City of Jeffersonville

**Combined Sewer Overflow Interceptor Design— 60% Design Development
Value Engineering Quality Assurance Quality Control
Report and Recommendations**

January 2014

Figure 1 – 60% Design Overview of CSO Interceptor

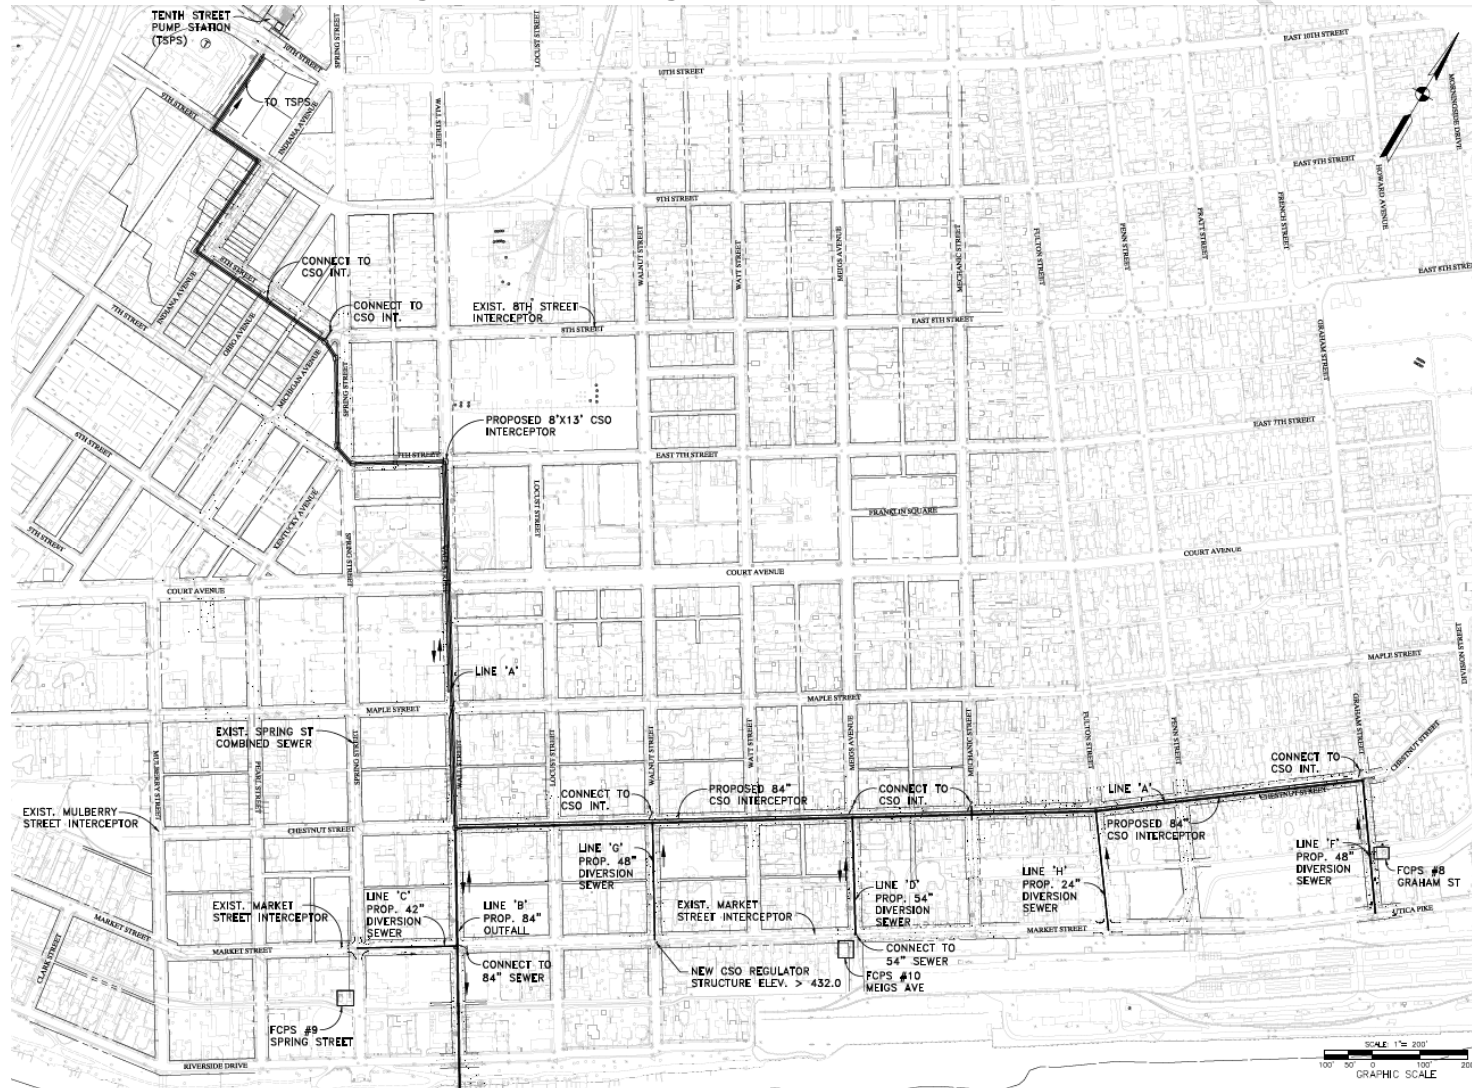
The design generally consists of 84-inch diameter sewer pipe east-west along Chestnut Street, north-south along Wall Street until they join at the intersection of Chestnut and Wall, where a 13-foot tall by 8-foot wide box is planned to convey the joining flow north and west along Wall, 7th, Spring, and 8th Street to and along Indiana Avenue, 9th Street and then connecting through easement to the TSPS. **See Figure 1 – 60% Design Overview of CSO Interceptor.**

Near constant dewatering is anticipated required for the installation of the interceptor. Further, to accommodate existing conditions, the slope of the interceptor throughout will NOT meet the minimum 10-State Standards. The City / Design Team indicated as a result they will be seeking an exemption from IDEM during the permitting process.
